CENTERVILLE CITY PLANNING COMMISSION AGENDA

Short Title: Public Meeting - Final Subdivision Plat - Moss Acres, 2026 North Main

**STAFF REPORT
AGENDA: ITEM 1**

APPLICATION: FINAL SUBDIVISION WITH HILLSIDE OVERLAY

MOSS ACRES

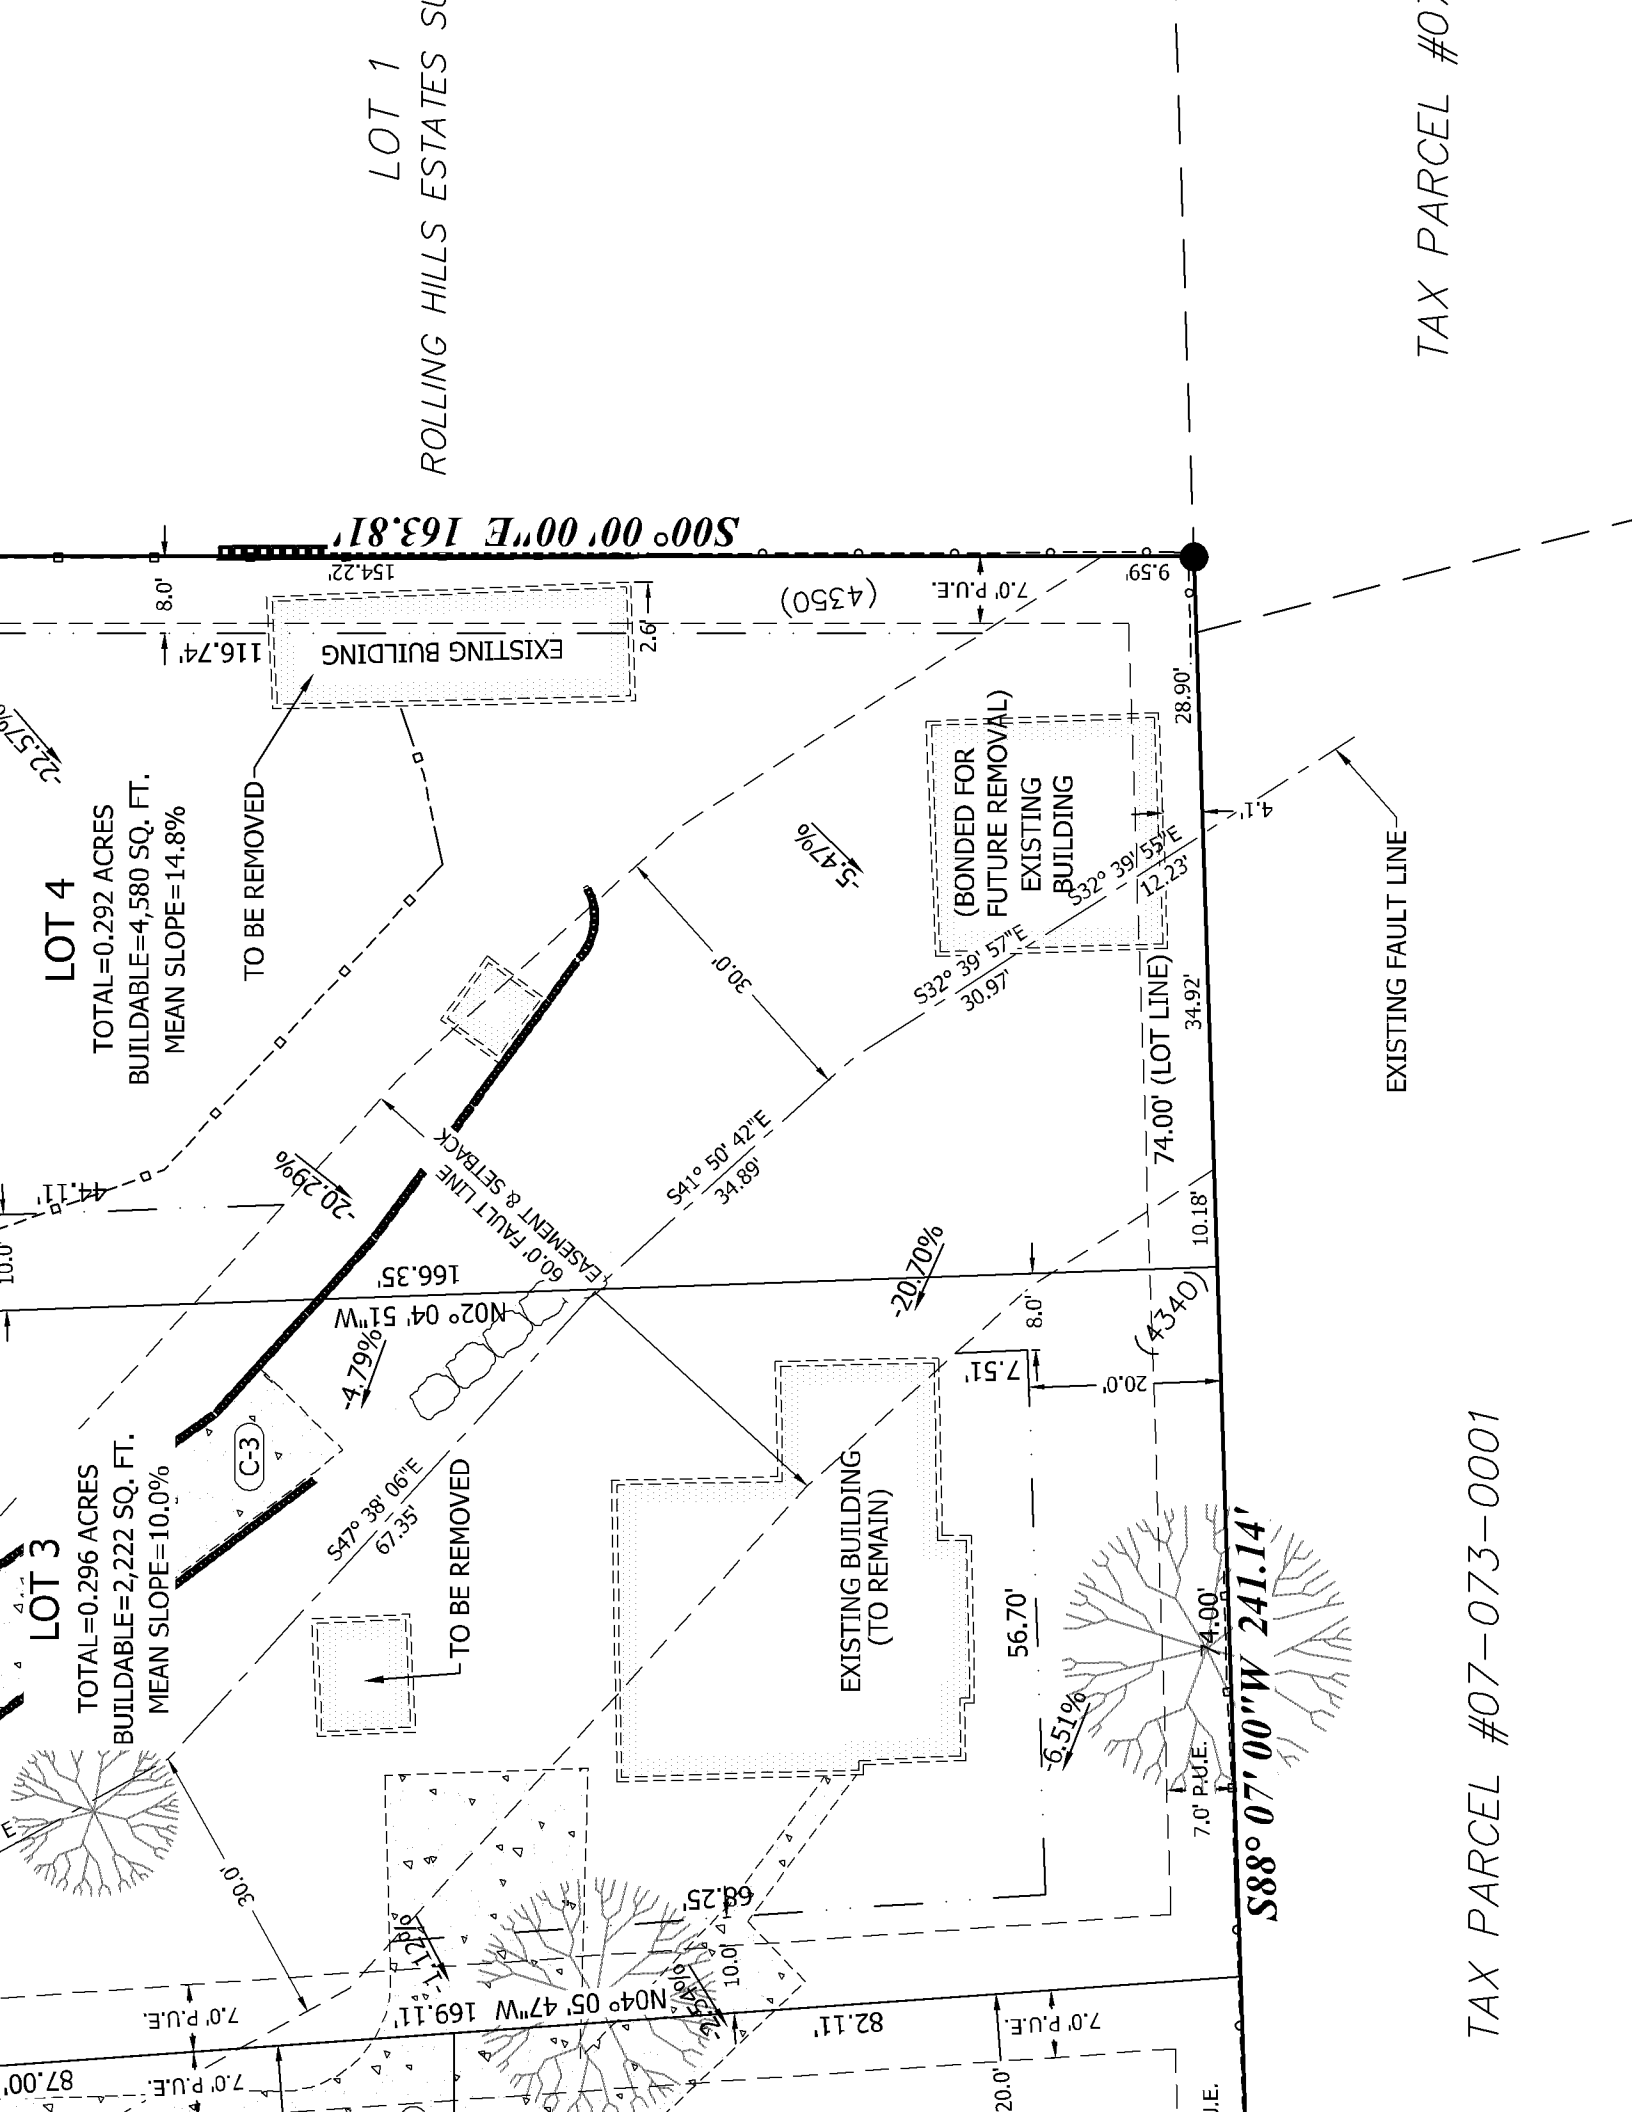
- The undefined building depicted on Lot 4 needs to also be removed.
✓ Noted for removal
- The building to remain on Lot 4 would be inconsistent with the zoning regulations. However, a compromise would be to let the developer temporarily keep the building and market the lot.
✓ Applicant shall bond for the removal, and may remain if the property is developed with 18 month of approval.
- Driveways – “In an effort to eliminate property wonder confusion, all existing driveways or cemented parking areas straddling property lines shall be removed to no less than one foot from the property line, unless the driveways parking areas are planned to be used as a part of shared driveways.” – Demolition Plan submitted March 5, 2018. ✓

2. The Final Plat shall provide a plat note indicating that the Max. Impervious Coverage is 40% or 5,000 sq. ft., whichever is less. COMPLETE, SHOULD ADD “PER LOT” TO NOTE

- 3. Plat Note Number 2 shall be edited to say "Maximum impervious coverage is 40% or 5,000 square feet per lot, wherever is less" before recording of plat.

- 4. Confirm proposed addresses with Public Works Director and label on the final plat before recording.
- 5. Plat shall state the Centerville City Standards as approved by the City Engineer.

- 6. Applicant shall add "Name" to the Owner's Dedication and Acknowledgment before recording of Final Plat
- 7. Applicant shall add location and reference to Centerville City easement E#900358, B#1367, P#723, prior to recording of the Final Plat.

9. Applicant shall provide legal existence of MorrisRigby LLC.
10. Applicant shall correct the boundary description on the plat to match the one listed on the title report, as approved by the City Attorney, before recording of the Final Plat.
11. Applicant shall post a bond for the demolition of sheds on the property. The bond may be released when the sheds are removed or IF a primary residence is constructed within 18 month of approval of the Plat.
12. The required improvement bond and associated fees shall be prepared, reviewed, and paid prior to the recordation of the subdivision plat with Davis County
13. After the plat recording, a preconstruction meeting shall be held with the City that includes all parties that are installing the public and utility service infrastructure
